**KERR-McGEE CORPORATION**

Reference: Source Material License SUB-1010, Docket 40-827,
 Kerr-McGee Sequoyah Facility

Subject: Summary list of replacement pages, Revision 4/10/70

FIGURE IV-1
Revision 4/10/70

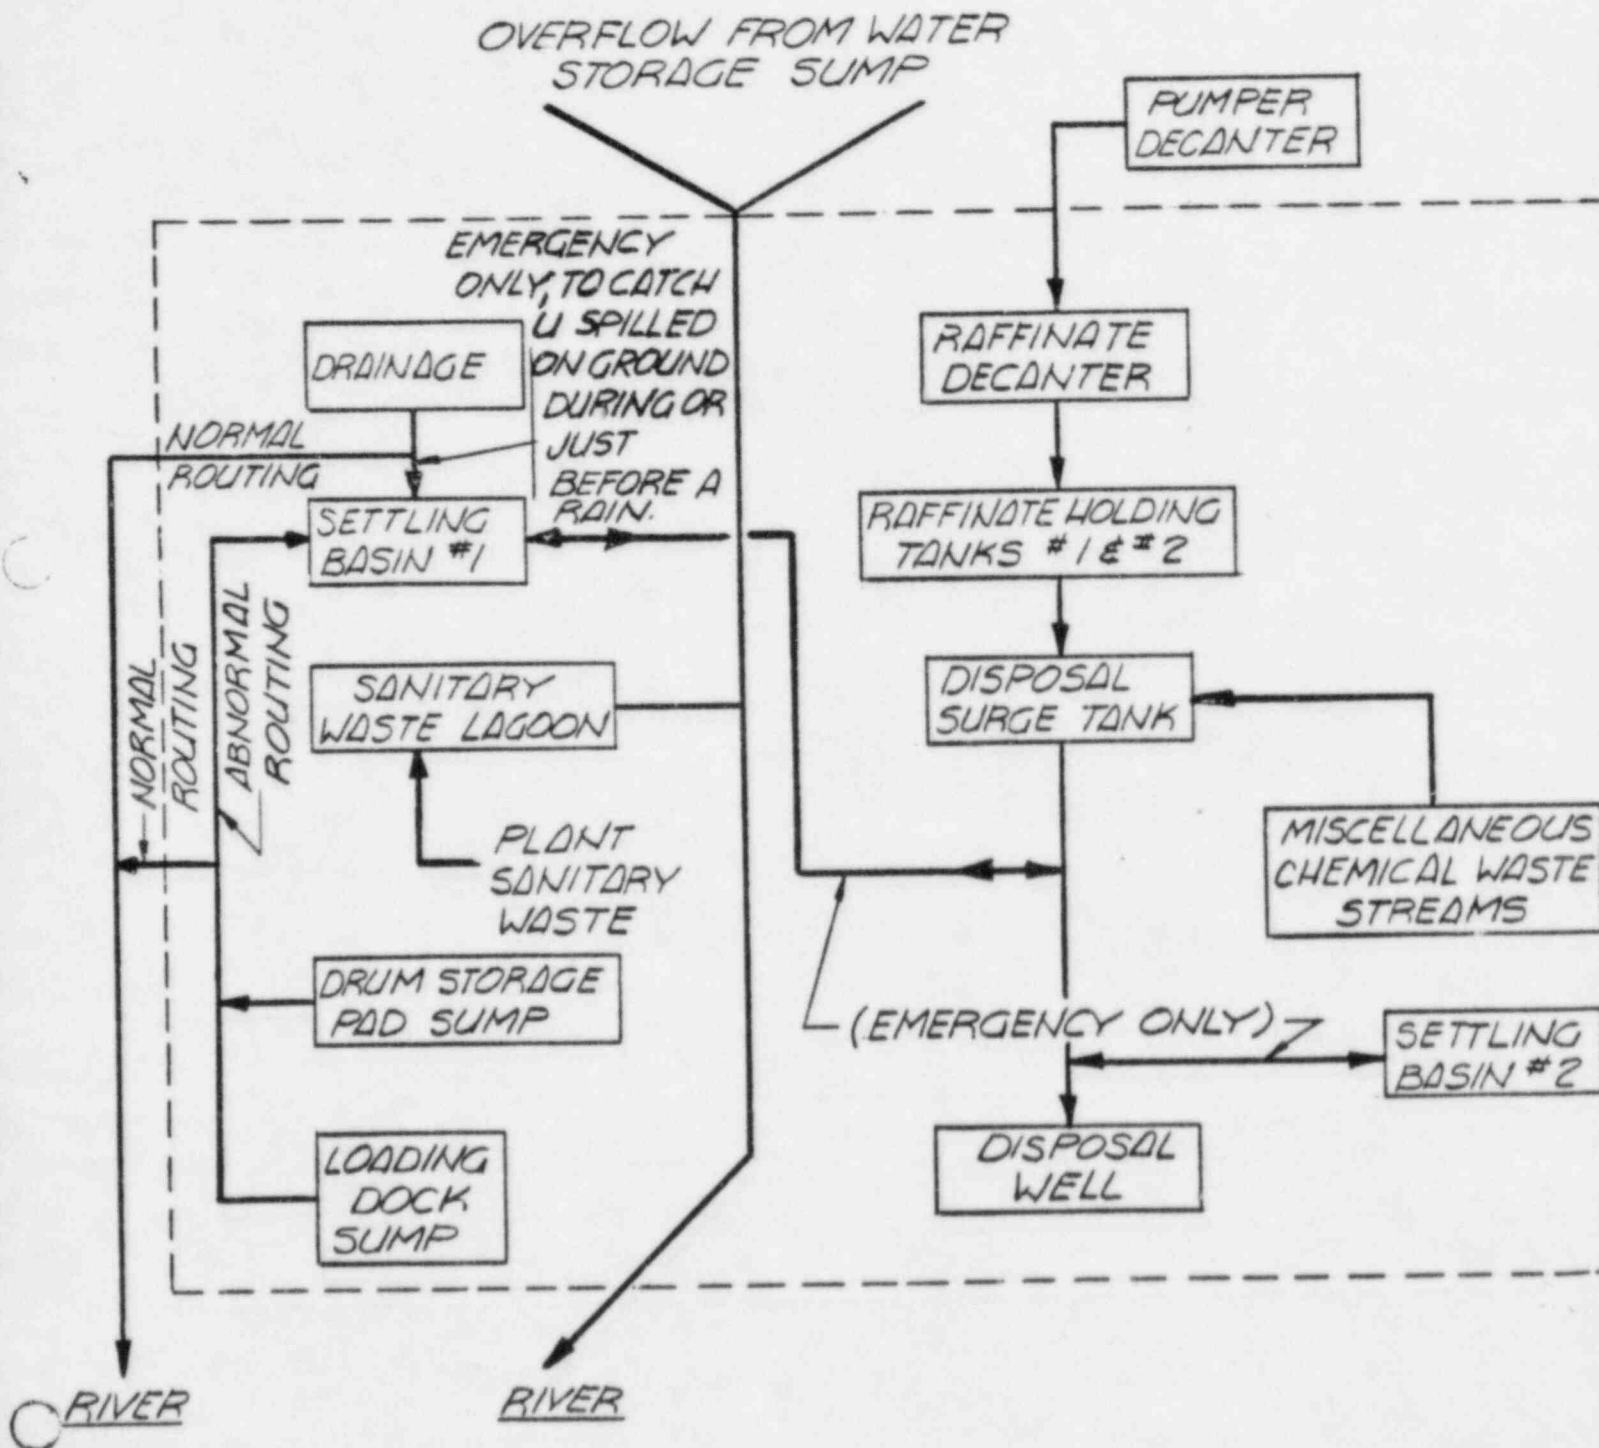
A simplified sketch of the liquid waste system is shown on Figure IV-1. The Oklahoma Water Resources Board has approved the overall waste treatment plan within their jurisdiction.
